<b>Product / Process Change Notification (PCN)</b>	
<input checked="" type="checkbox"/> Major Change <input type="checkbox"/> Minor Change	
<b>PCN Number:</b> PCN_FeAFB_20241220  <b>Affected Series:</b> WE-AFB  <b>Affected Order Codes:</b> See table below  <b>PCN Date:</b> 2024-09-20 (YYYY-MM-DD) <b>Effective Date:</b> 2024-12-20 (YYYY-MM-DD)	<b>Change Category:</b> <input type="checkbox"/> Equipment/Location <input checked="" type="checkbox"/> General Data <input type="checkbox"/> Material <input type="checkbox"/> Process <input type="checkbox"/> Product Design <input type="checkbox"/> Shipping/Packaging <input type="checkbox"/> Supplier <input type="checkbox"/> Software
<b>Contact:</b> Product Management  <b>Phone:</b> +49 (0) 7942 - 945 5001  <b>Fax:</b> +49 (0) 7942 - 945 5179  <b>E-Mail:</b> pcn.eisos@we-online.com	<b>Datasheet Change:</b> <input checked="" type="checkbox"/> Yes <input type="checkbox"/> No  <b>Attachment:</b> <input type="checkbox"/> Yes <input checked="" type="checkbox"/> No

<b>Description of Change:</b> <p>For the purpose of a datasheet information enlargement and internal standardization, Würth Elektronik will implement a new measurement setup to improve t

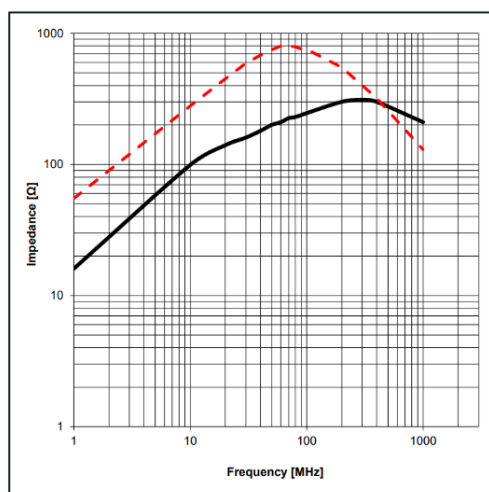
3. The visualization of chart for the **“Typical Impedance Characteristics”** changes. The used type of cable and cable length is shown in each chart.

**BEFORE CHANGE:**

- Showing only one graph with 1 turn (1T) and 2 turns (2T) impedance curves.

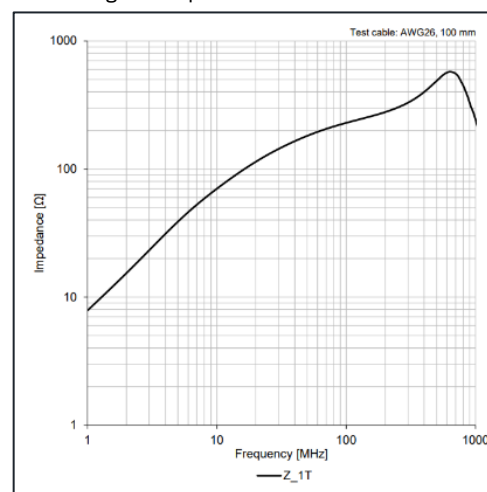
**AFTER CHANGE:**

- Showing a graph for the 1 turn (Z\_1T) impedance curve with the shortest possible cable length according to the product.

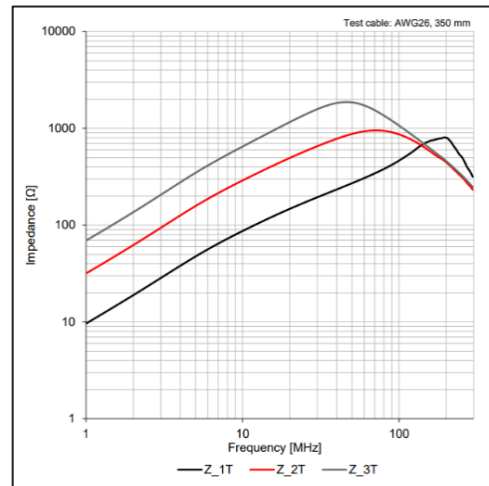
Showing no graph with 3 turns impedance curve.

Showing a graph for 1-3 turns ( $Z_{1T}$ ,  $Z_{2T}$ ,  $Z_{3T}$ ) impedance curves with the shortest possible cable length, which is required for 3 turns according to the product.
